Town of Parker Community Development Department
Development Review Division
Attention: **Stacey Nerger**

Application Type: **Site Plan**
Status: **First Referral**
Application Name: Parker Town Hall Exemption Plat AMD3 L1 Town Hall Addition
Case/AP#: **SP23-097**
Referral Received: November 17, 2023
Comments Due: December 19, 2023

TOWN OF PARKER FIRE/LIFE SAFETY:	C REVIEWED FOR CODE COMPLIANCE w/COMMENTS
---	--

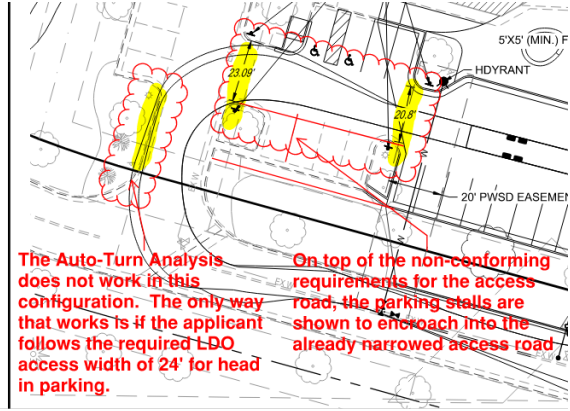
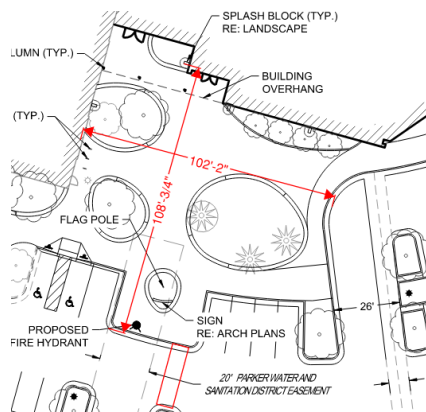
3. The applicant has only partially addressed the requirements of [21 IFC Appendix D for Aerial Apparatus Access roads. This sections requires that an aerial apparatus road be provided along the ENTIRE length of the building. In this case, only a portion of the reworked southern access was reworked to meet this requirement. Further, Appendix D requires that “access routes meeting this condition shall be located not less than 15 feet from the building and not greater than 30 feet from the building and shall be parallel to the entire side of the building”.

The portion of the access drive that does not meet the width requirement is shown below: *Not satisfied; applicant has not addressed this issue with the second submittal. The westerly portion of the access (see immediately below, does not meet aerial apparatus road requirements of the code (though I would allow the applicant to meet the required LDO requirements of the Town placing this part of the road at the required 24-feet in width. In addition, the auto-turn analysis does not work with the non-conforming access width. Address this issue as required when resubmitting. Satisfied; the applicant has addressed this issue with the third submittal.*

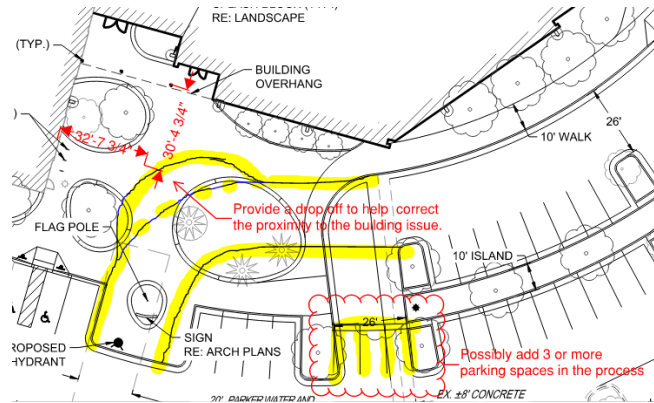
The portion of the access drive that does not meet the “proximity the building requirements is shown below: *Satisfied; the applicant has addressed this issue with the second submittal. Thank you!*

An option to solve the “proximity to the building” issue would be to extend the new main entry up towards the building and over to the north allowing for the access requirements to be met.

Note – another option would be to design the plaza to incorporate the required fire access road in the area identified above. Ultimately, it will be up to the design team to show how they can meet the requirements for aerial apparatus roads. Address this issue when resubmitting to ensure compliance with the requirements of the fire code.

Correct Signature Block/Configuration:

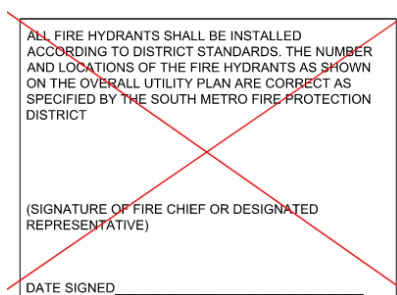
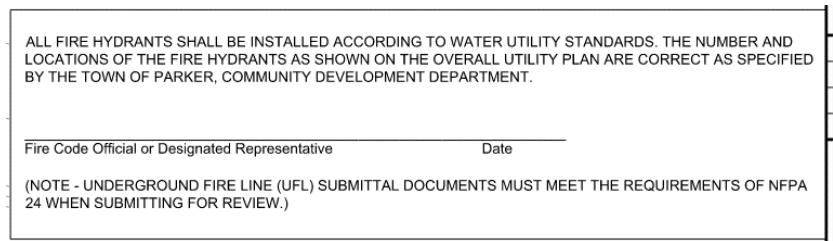
- The “approved” fire life safety signature block is required on both the cover sheet and the overall utility sheet of the utility plans; a copy of the block is provided at the end of this document. *Not satisfied with the second submittal; while the applicant has provided the correct signature block on the overall utility page, the applicant has not provided the correct signature block on the cover sheet of the utility drawings. When providing the correct signature block, do not modify the configuration of the block as doing so will not accommodate the electronic stamp that is used by Fire Life Safety to stamp the drawings. The configuration of the incorrect block used by the applicant is too narrow. See below:*

Incorrect Block/Configuration:

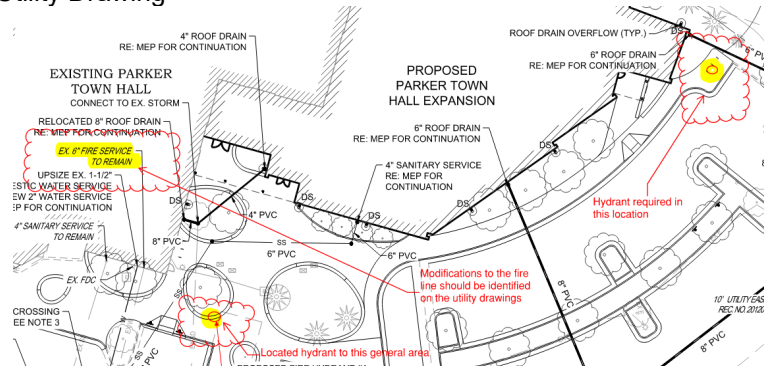
- Modifications to the underground fire line (UFL) will be required to remove the existing domestic tap; the utility drawings have not addressed this requirement. *Not satisfied with the second submittal; while the applicant has documented the new domestic water service, the UFL has been shown as existing. This is not correct. A portion of the UFL is being modified to remove the existing domestic. This should be identified as “new”, and a deferred permit will be required to address this scope of work. Not Satisfied; applicant has not addressed with the third submittal. The scope of work does not identify the work required to relocate the domestic irrigation tap; as this is not identified, the scope of work will still require a permit for modifications to the existing UFL. The deferred permit for this scope of work will require that a fire watch be provided for the building, that the riser is removed from the flange where the UFL enters the*

building, the work to remove the tap domestic tap will be identified, the fire line reinstalled, a flush test completed before the riser can be replaced, the required hydrostatic test, and visual inspections will be completed and signed off. Once this has been completed, the fire watch can be terminated. This is a redlined required comment.

[AMD response] Per meeting on 04/29/2024 with Randy Capra, Randy Sale, Bob Exstrom, JHL Constructors, AMD Architects - GC will obtain a deferred permit for the UFL modification - to remove the existing domestic line from it. GC verbally agreed to the requirements noted below (flush test, fire watch, etc) as part of this scope of work.

Marked up Utility Drawing

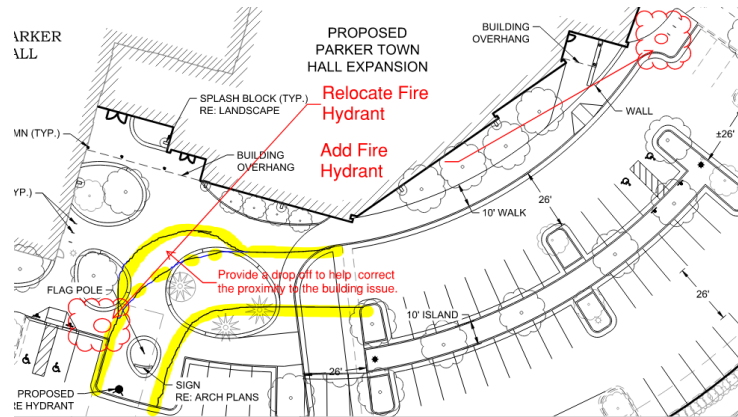
- **A fire hydrant is required to be provided on the east side of the new building (north end of inside parking lot). Satisfied; the applicant has addressed this issue with the second submittal. Thank you!**
- The fire hydrant located at the new main entry was to have been relocated to the west (based upon the aerial apparatus access road, I would suggest relocating the fire hydrant in an area shown below: **Satisfied; the applicant has addressed this issue with the second submittal. Thank you!**

Note – Based upon the modifications noted to meet the aerial appraisal requirements of the code, the fire hydrant located at the s/w corner of the existing building (that was to be relocated) shall be relocated in the area shown in the snapshot below. I will include both the access routes (whether plaza access or access road) with the proposed relocation for the fire hydrant as either scenario will require the hydrant to be relocated to the same general location.

Current Auto-Turn:

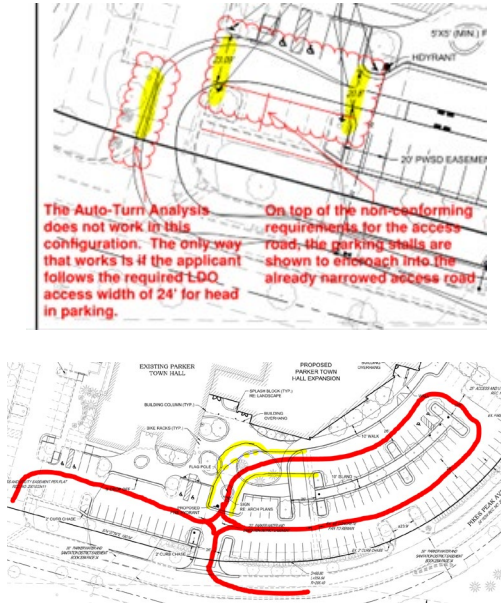
- The applicant shall provide an auto turn analysis indicating that apparatus can navigate all portions of this site; NO PARKING – FIRE LANE signage is required for any portion of the access where the 20-foot clear width requirement cannot be met. *Not satisfied with the second submittal; the auto-turn analysis does not work at the western entry/egress of the site. Address this issue when resubmitting: Note - This issue was identified above and is shown again, below. Satisfied; the applicant addressed with the third submittal.*

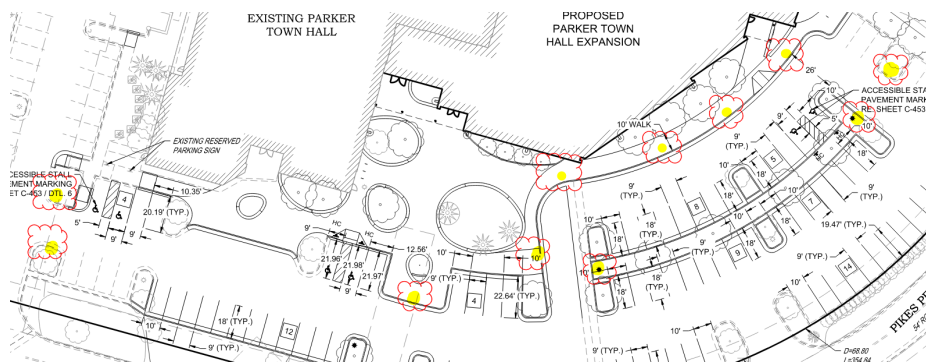
Note – the area identified with the two blue rectangles is of particular concern. People tend to not stay within the lines and the 20-foot drive aisle on the south end creates a potential for delays in response specific to staged or waiting vehicles in this area. Ensure that this issue is addressed adequately or provide signage that states **NO PARKING OR STANDING – FIRE LANE** in this area (area shown on west side of building... south end as well as the south side of the building).
